Government of India
Ministry of Railways
Research, Designs & Standards Organisation
Manak Nagar, Lucknow - 226 011

No.EL/2.2.1/1

MODIFICATION SHEET NO. RDSO/WAM4/170
ADOPTION OF STEEL STRIPS IN PLACE OF EXISTING CARBON
STRIPS FOR SMC PANTOGRAPH TYPE BR 23 LE.

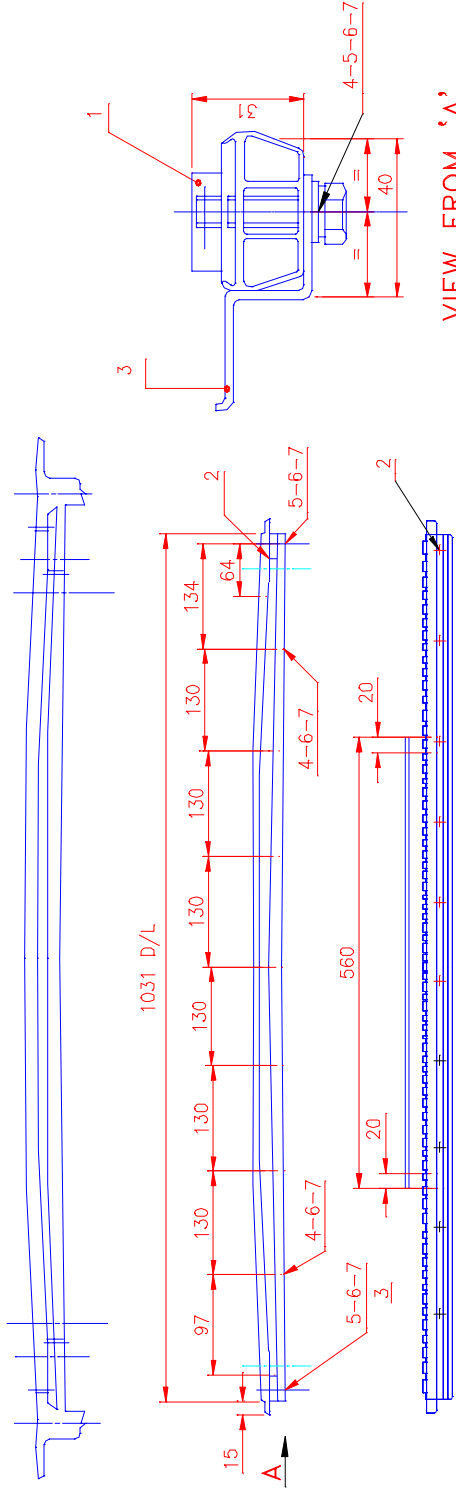
- 2.1 Grid the carbon strips to make it levelled. The height of the horn should be 7.0mm above the grinded portion (to accommodate the height of the steel strips i.e. 7.0mm)
- 2.2 Taped holes to be drilled in the grinded carbon strips as per details given in the drawing enclosed.

- 2.3 A new steel strips with width and thickness same as that of existing strips (7.0mm thick and 25.00mm wide) and total length of 1061 mm may be procured from stone India. The material composition of the strip shall be identical to those procured for fitment on AM12 pantographs. Till such time the new strips are available from M/s Stone India, the existing strips available with the shed/CLW may be tailored to suit the requirements as shown in RDSO`s drawing No. SK. EL.-4093 Sheet 1 and 2.

1. CARBON ON SMC PANTO CONTACT STRIP BASE SUPPORT SHOULD BE GROUND TO MAKE IT LEVEL.
2. SMALL PIECE (REF-2) TO BE CUT & BOLTED TO REF-1 AND GROUND.
3. THE TAPPED HOLES TO BE DRILLED ON SMC PANTO CONTACT STRIP BASE SUPPORT AFTER MARKING WITH THE HELP OF CONTACT STRIP (REF 1 & 2).
4. REF-3 SHOULD BE PROVIDED AFTER DRILLING HOLES IN POSITION.
